• 2014 DRC SUBMISSION – Proposed revisions to Tucson 2 project

LIST OF PROPOSED CHANGES

The Hub at Tucson II

CHANGES SUBMISSION. **PROPOSED**

Proposed North Elevation

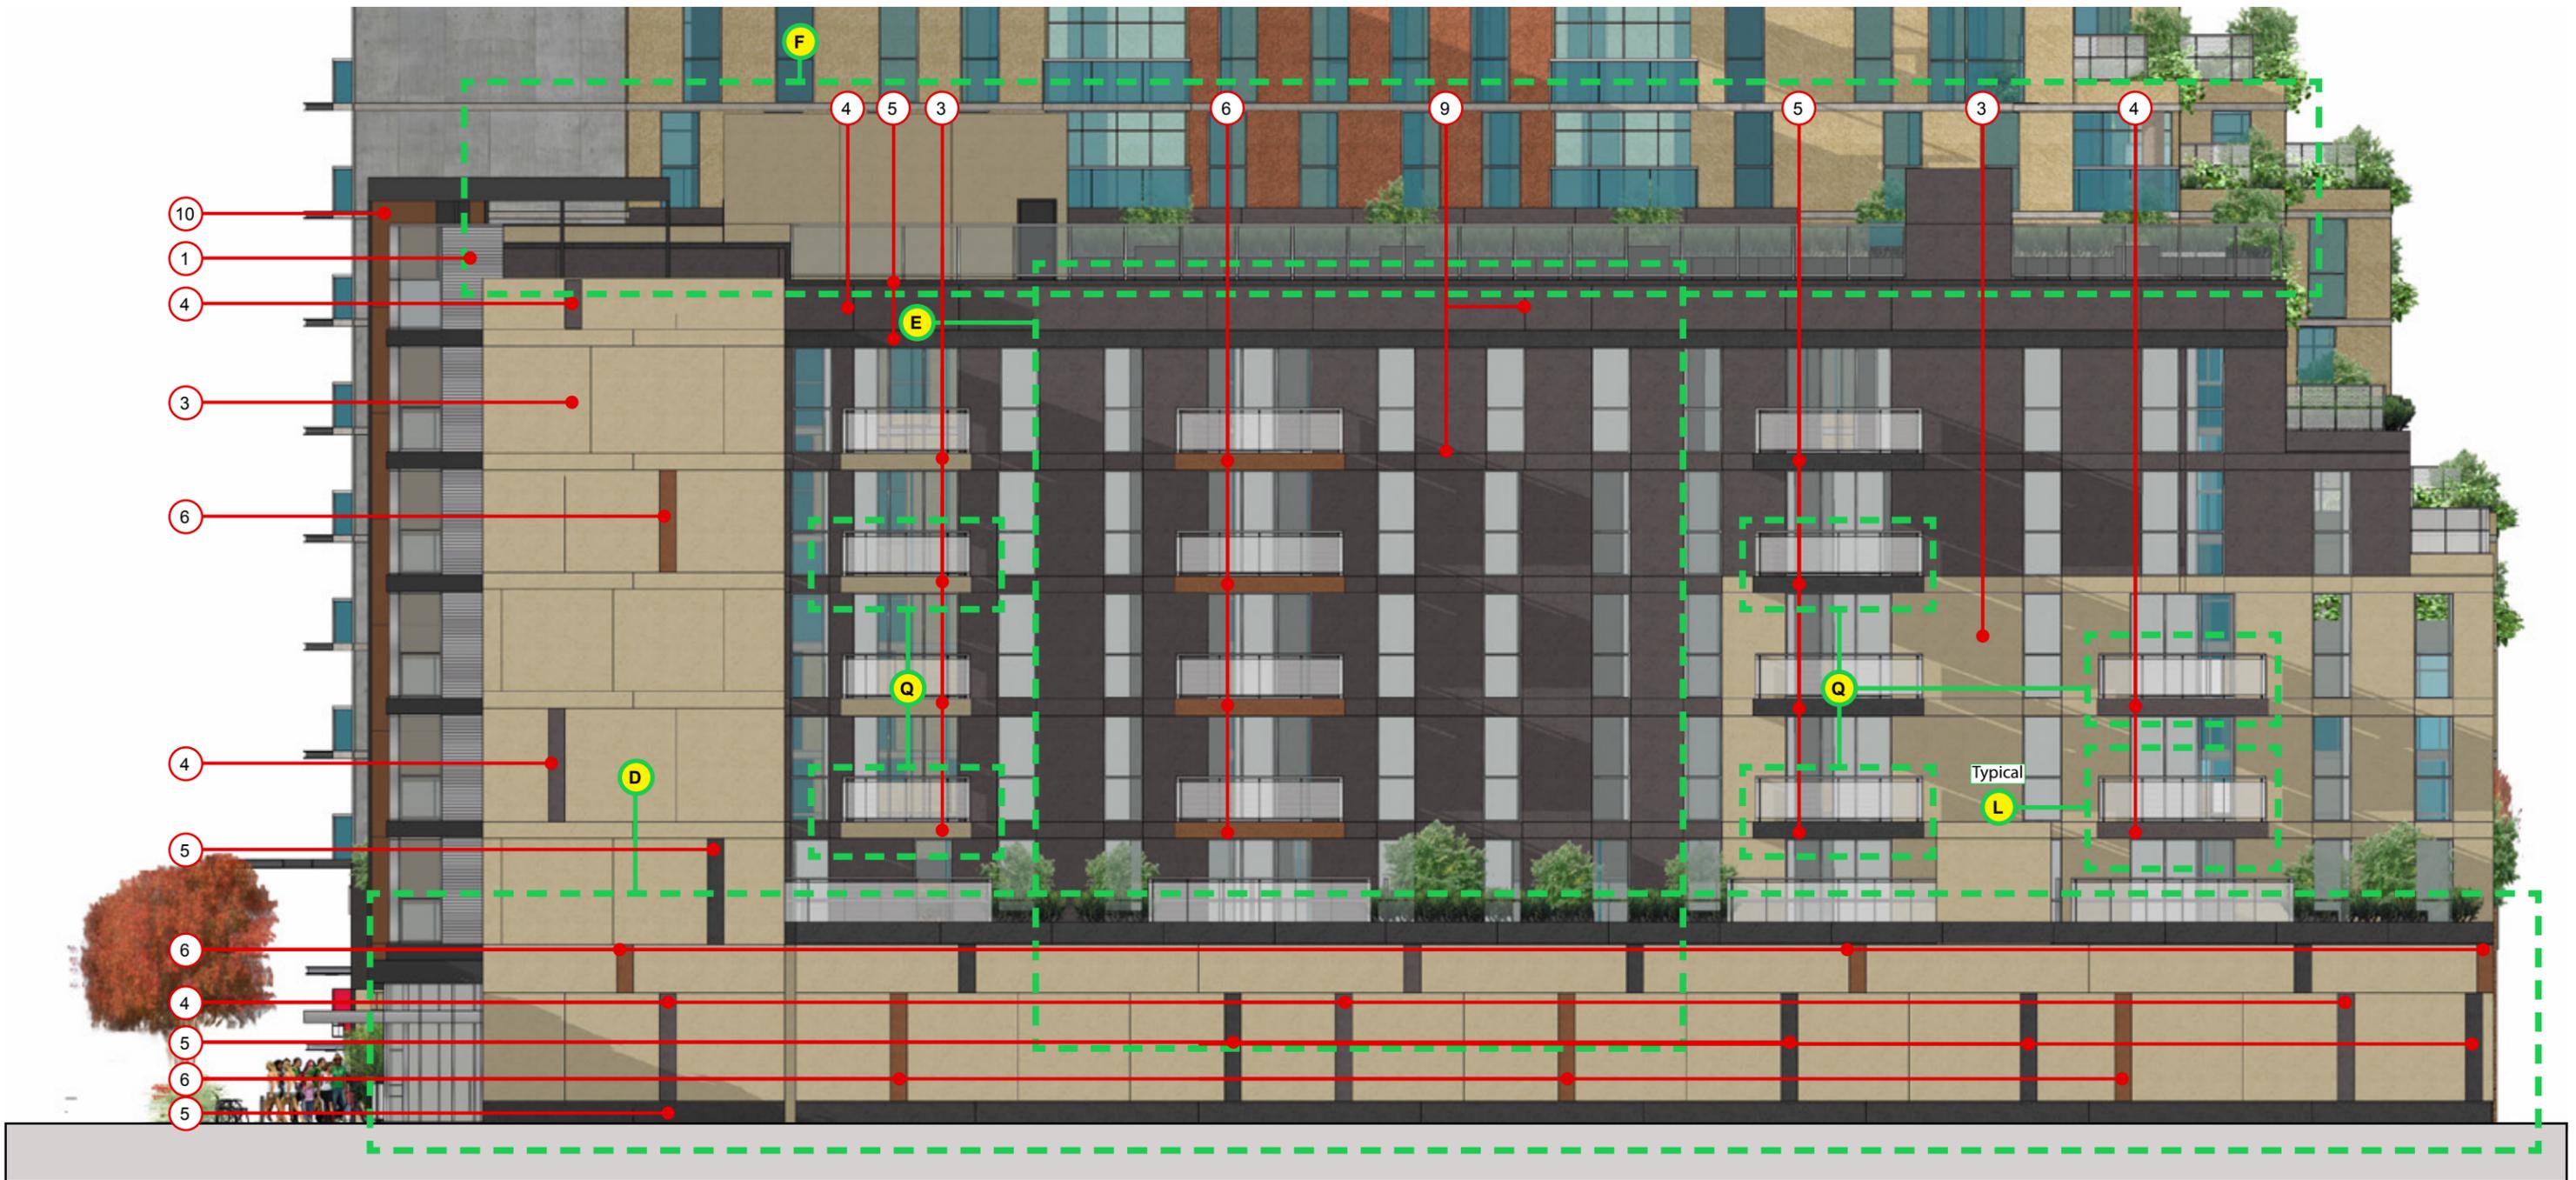
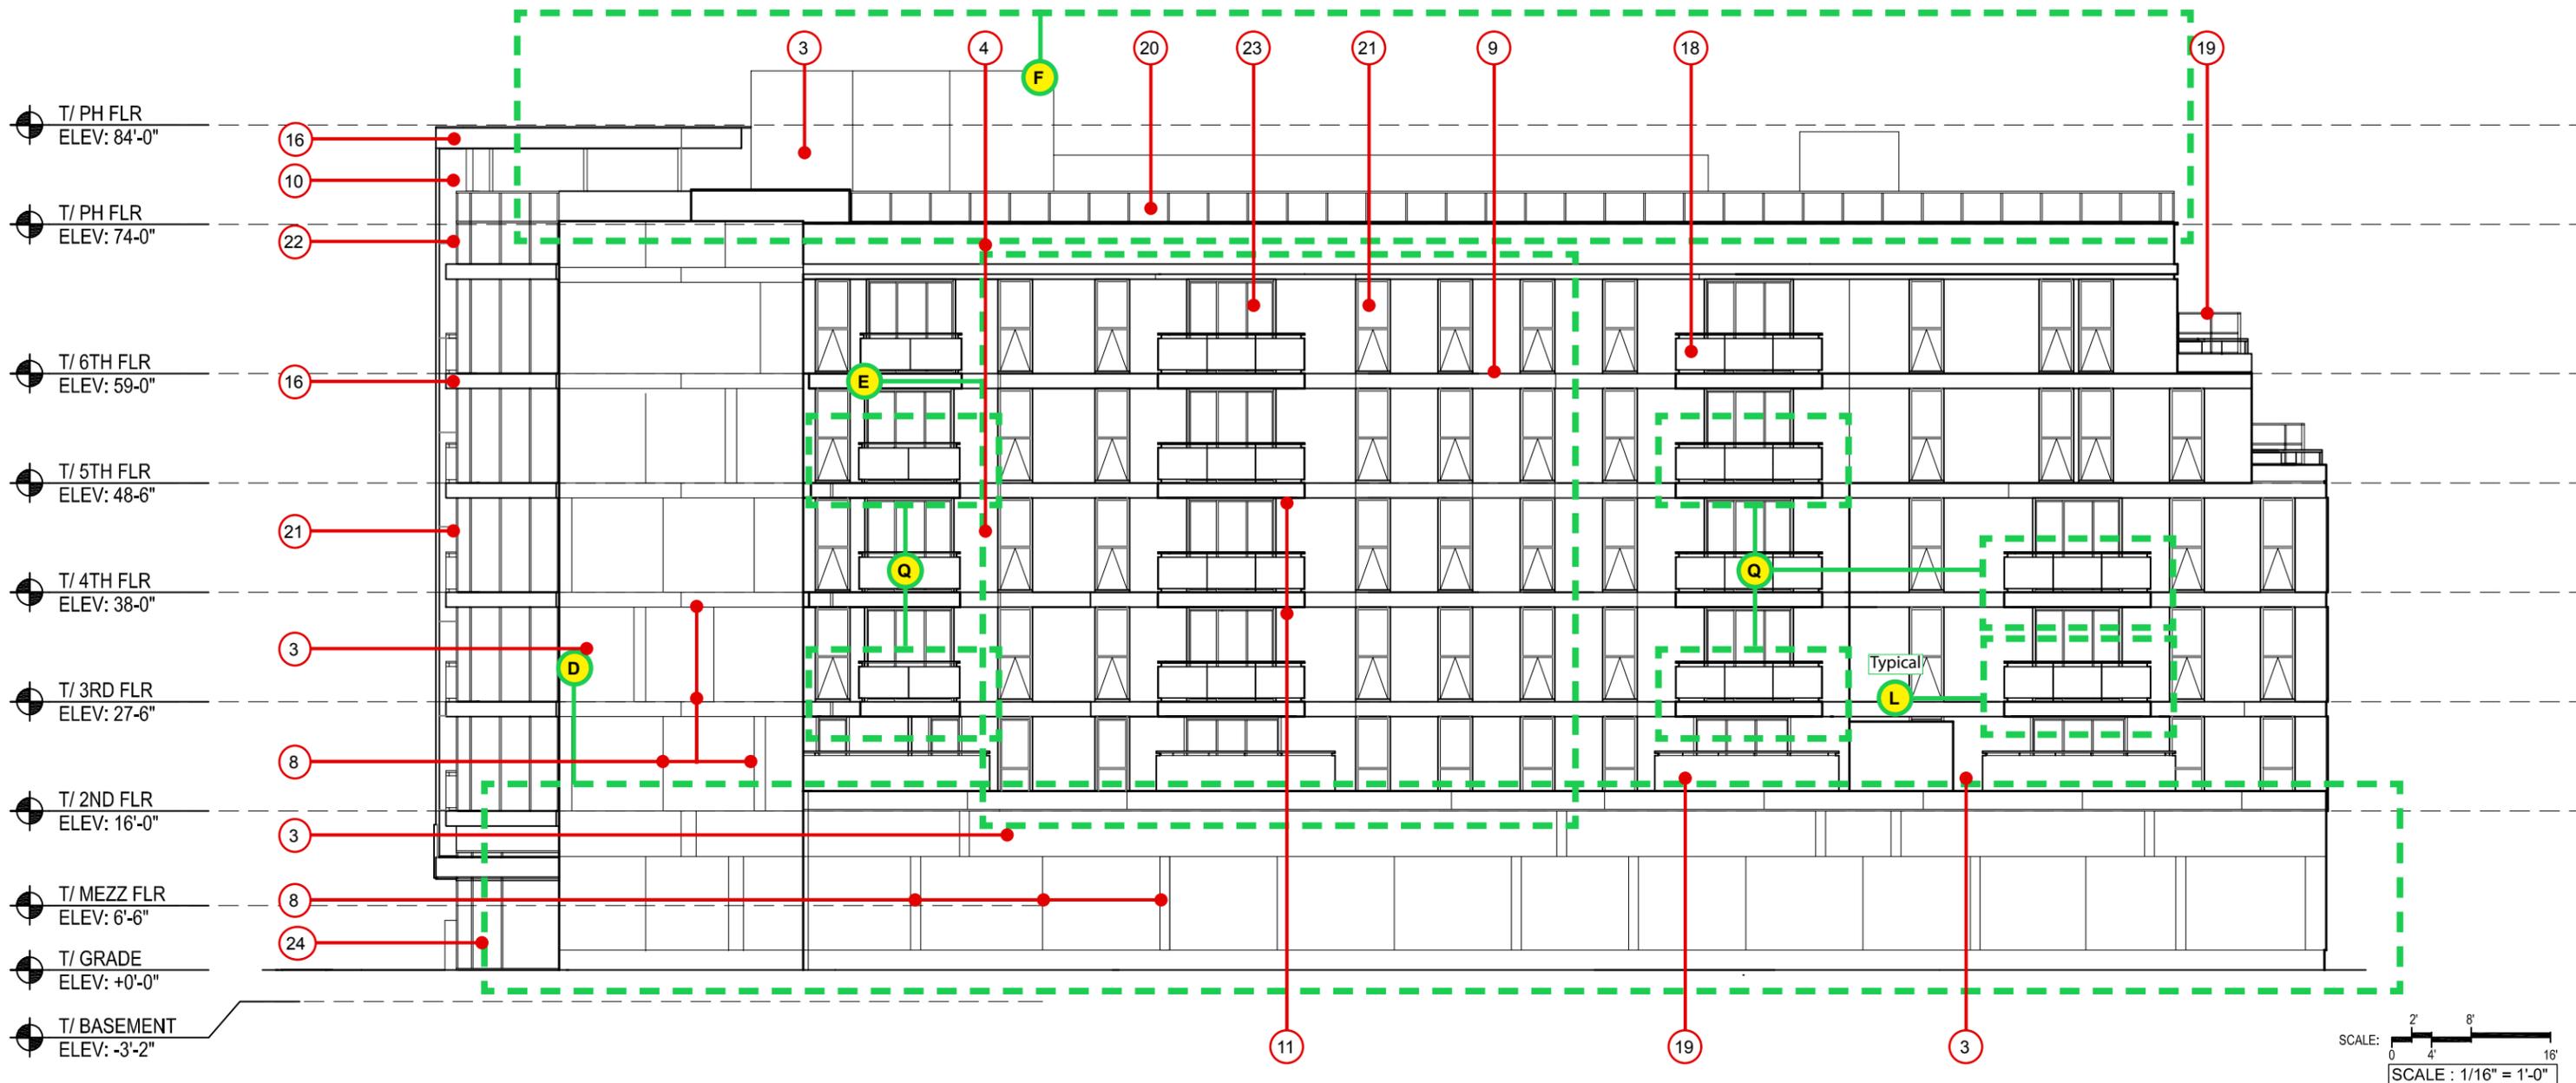
- **D** - Addition of mezzanine units to the north wing of the building.
- **E** - Duplex units added to center of north wing and balcony arrangement altered. Associated Balconies increase in width from 15' to 18'. Layout and extent of glazing on north façade changed from 3,006 sqf (Approved scheme) to 3,784sqf (Proposed scheme), resulting in 778 sqf of additional glazing.
- **F** - Rooftop terrace area reduced, pool and hot tub relocated to the courtyard. Rooftop terrace screen material changed from glass infill to metal panel infill. Extent of mechanical screen increased to location on the north wing. Landscaping altered to suit new layout.
- **L** - All balconies reduced from 6' to 5' deep, excluding balconies on Tyndall street.
- **Q** - Number of balconies reduced on the north and south elevations from 26 to 16.

GLAZING AREA'S ON NORTH FACADE.

APPROVED SCHEME TOTAL 3,006 sqf

PROPOSED SCHEME TOTAL 3,784 sqf

GLAZING INCREASE 778 sqf
